Access Compliance Report

Public Rights-of-Way

(Curb Ramps)

Intersection ID: 25464	Main Street: ASHLIGHT_DR	Cross Street: HATTON_CROSS_DR	Location: SW
ADA ID: 1C61B22EBCA6	Ramp Type: PerpDiag	Initial Pass/Fail: Fail	Overall Compliance: No
		Severity Score: 35

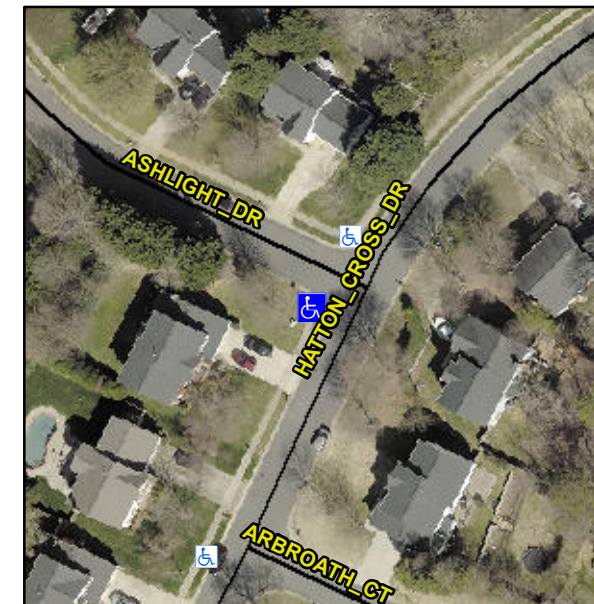
Not Found, R304.5.1

Compliance	Description	Data	Compliance	Description	Data
N/A	Ramp Length (in)	97.0	Yes	Ramp Slope (%)	6.2
No	Ramp Width (in)	31.0	Yes	Ramp XSlope (%)	2.0
N/A	Flare Type LT	N/A	N/A	Flare Type RT	N/A
N/A	Flare Slope LT (%)	N/A	N/A	Flare Slope RT (%)	N/A
N/A	Flare Traversable LT?	N/A	N/A	Flare Traversable RT?	N/A
N/A	Landing Length (in)	N/A	N/A	DWS Provided?	N/A
N/A	Landing Width (in)	N/A	N/A	DWS Contrast?	N/A
N/A	Landing Slope (%)	N/A	N/A	DWS Length (in)	N/A
N/A	Landing X Slope (%)	N/A	N/A	DWS Full Width?	N/A
N/A	Landing Curb? (Y/N)	N/A	N/A	DWS Offset (in)	N/A
N/A	Shared Landing?	N/A			
N/A	Gutter Ponding?	N/A	N/A	Gutter Slope (%)	N/A
N/A	Gutter Lip Ht (in)	N/A	N/A	Gutter X Slope (%)	N/A
N/A	Painted X Walk1?	No	N/A	Painted X Walk2?	No
	X Walk 1 Direction	To SE		X Walk 2 Direction	To NE
N/A	X Walk 1 Width (in)	N/A	N/A	X Walk 2 Width (in)	N/A
	X Walk 1 Slope (%)	1.4		X Walk 2 Slope (%)	10.6
	X Walk 1 X Slope (%)	6.7		X Walk 2 X Slope (%)	1.9

Remove & Replace Curb Ramp With Two New Directional Ramps or Equivalent.
